U.S. NUCLEAR REGULATORY COMMISSION
REGION I

Report No. 50-316/88-24

Facility Name: Donald C. Cook

Inspection Summary and Conclusions: A routine announced inspection was conducted at the D. C. Cook Nuclear Power Station on September 6 through September 15, 1988 (Report No. 50-316/88-24).

- FIG A IS THE OLD RADIOGRAPHIC TECHNIQUE
- FIG B IS THE NEW RADIOGRAPHIC TECHNIQUE
- FIG C IS JOINT DESIGN

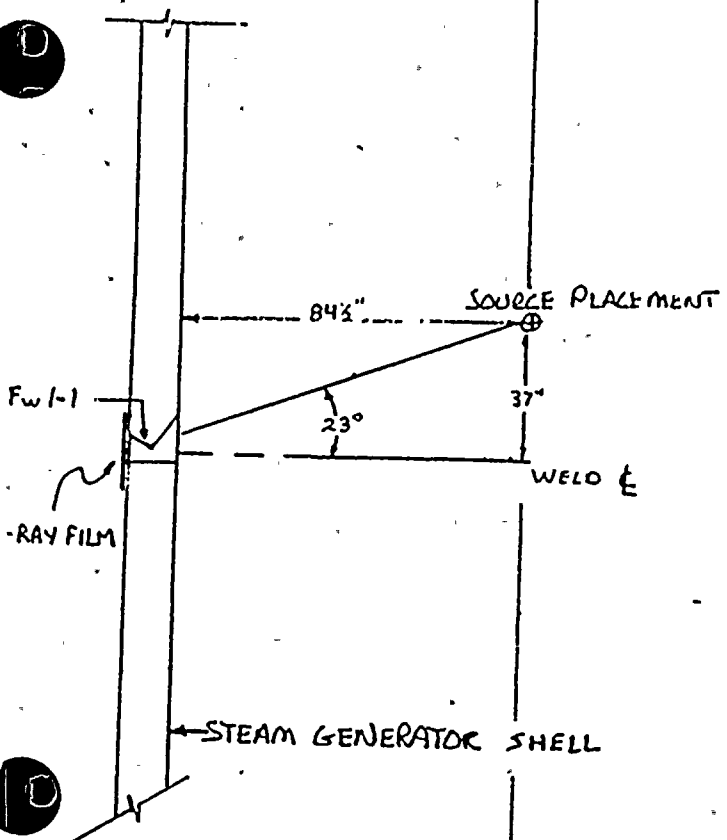
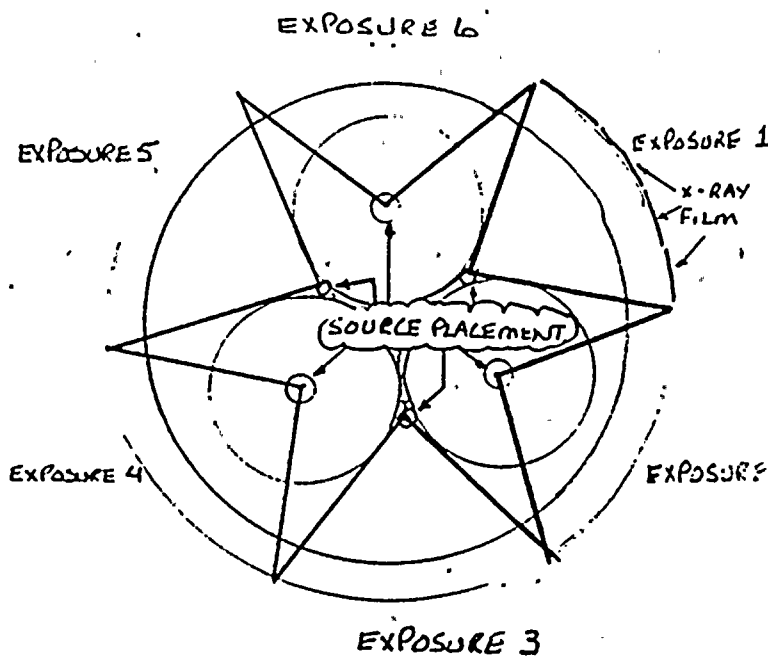
The inspector reviewed the radiographic technique employed by the licensee's contractor for radiography of the steam generator field girth welds. The radiographic set up consisted of centering the source tube on the I.D. of the steam generator shell course (87½" SFD) and positioning 300 curies of Cobalt 60 23° (37") off of the centerline of the closure girth weld (See Attachment 1). This technique does not comply with ASME Section V Article 22, Radiographic Standards; SE-142 Standard Method for Controlling Quality of Radiographic Testing; paragraph 3.0, Direction of Radiation. One of the five Geometric Principles of radiography states that the direction of the central beam of radiation shall be perpendicular to the recording surface (film). ASME Section V, Article 2 paragraph T-273 has the same requirement. Site radiographic procedure FQP-9.4 attachment 3 displays three suggested techniques that meet SE-142 paragraph 3.0. These techniques could have been used to radiograph these girth welds but were not employed. ASME Section V, Article I, paragraph T-110(e) requires when special techniques are used they must be equivalent to or superior to the techniques described in the Code Section. The techniques shall be capable of detecting discontinuities by demonstration and shall be equivalent to the capabilities of the techniques described in the Code. A review of the welding history of these girth welds indicated above normal frequency of weld defects. On September 12, 1988, the NRC radiographed two film areas out of 42 on steam generator number 21 girth weld FW1-1. The NRC radiographic technique used was to place the film on the ID while the source was centered on the weld on the OD at 30" SFD. A 37 curie cobalt 60 source was used. This technique is in site procedure FQP9.4 attachment 3(c). NRC film area 23-24 disclosed a rejectable slag indication that ran the entire length of the film (17"). A review of the licensee's radiograph for this same area disclosed that this indication was not present. It was the inspector's understanding that this girth weld, FW-1-1, was to undergo post weld heat treatment (PWHT) after the NRC was finished with the radiography of the weld. The inspector also understood that the licensee planned to use the same configuration to perform radiography after PWHT that they had used originally with the exception of using

type "AA" film rather than type "T" film. The licensee changed their radiographic technique after review of the NRC film for area 23-24. The improved radiographic technique as described in site radiographic procedure FQP9.4 attachment 3 is in use now. This technique meets SE 142 paragraph 3.0 requirements. (See attachment 1). Use of radiographic techniques not satisfying applicable ASME Code requirement is an apparent violation (50-316/88-24-01).
